Board of Zoning Appeals Meeting

December 21, 2021

CASE NUMBER:	V-21-011
PROPERTY LOCATION:	9395 Riverclub Parkway, Johns Creek, GA 30097
CURRENT ZONING:	R-2 (Single-Family Dwelling District) Conditional
PARCEL SIZE:	1.34 Acres
PROPERTY OWNER:	Douglas H. Wilson
VARIANCE REQUEST:	41-foot encroachment into the 50-foot undisturbed buffer and 75-foot impervious surface setback to construct a porch
STAFF RECOMMENDATION:	APPROVAL WITH CONDITIONS

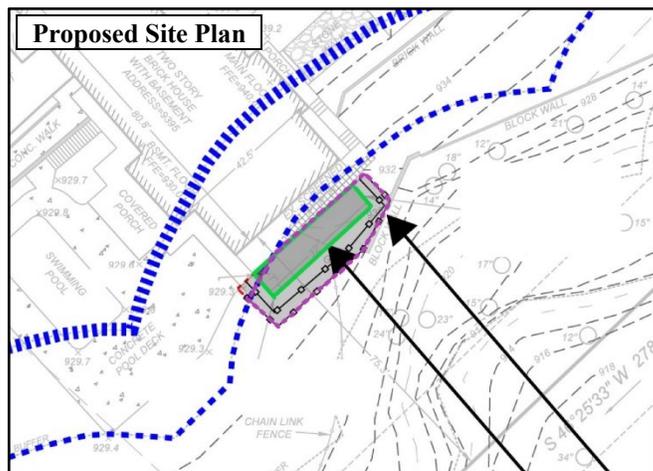
The Applicant is requesting to encroach 41 feet into the stream buffer to disturb 470 square feet (outlined in purple) in the 50-foot undisturbed buffer, add 224 square feet of impervious surface (in green) in the additional 25-foot impervious surface setback to construct a porch, and to bring the entire property into compliance with the Stream Buffer ordinance. The Applicant has not proposed any land disturbance or impervious surface within the State’s 25-foot stream buffer.

- 1) The proposed development shall not exceed the following encroachment, as shown on the site plan received by the Community Development Department on November 9, 2021:

- a. 41 linear feet of encroachment into stream buffer
 - b. 470 square feet of disturbance within the 50-foot undisturbed buffer
 - c. 224 square feet of impervious surface within the 75-foot impervious surface setback

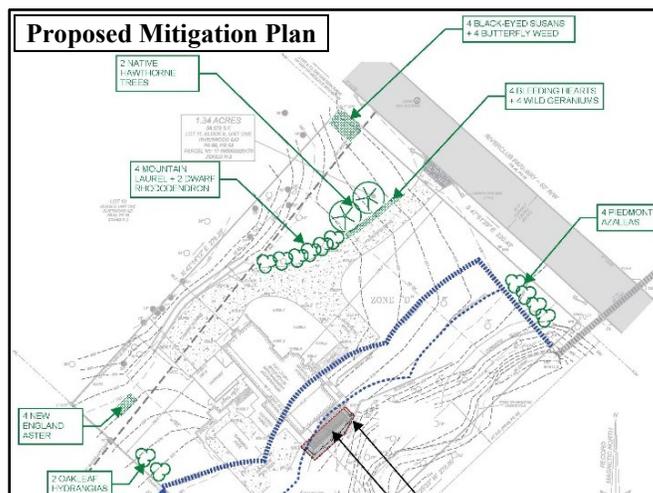
In order to offset the adverse impacts associated with the encroachment, the Applicant has proposed to plant 2 small trees, 12 shrubs, and 80 square feet of groundcover (shown in green on the Proposed Mitigation Plan).

In order to mitigate the impact of encroachment, the Applicant has provided a vegetative planting plan to reduce and slow stormwater runoff associated with the additional impervious surface. Staff has also recommends a condition for installation of a dry well to hold at least 23 cubic feet of stormwater runoff.

- 2) A vegetative planting plan shall be submitted to the Community Development Department, and approved by the City's Land Development Manager, prior to the issuance of a building permit. Said plan shall be consistent with the mitigation plan received by the Community Development Department on November 9, 2021. The final vegetative planting shall pass City inspection prior to the issuance of a Certificate of Completion.

- 3) The applicant shall install a dry well that retains the first 1 inch of rainfall from the 224 square feet of impervious surface. The dry well location and design shall be approved by the City's Land Development Manager prior to the issuance of a building permit, but the dry well location shall not encroach further than the linear distance permitted by this variance. The dry well shall pass City inspection prior to the issuance of a Certificate of Completion.
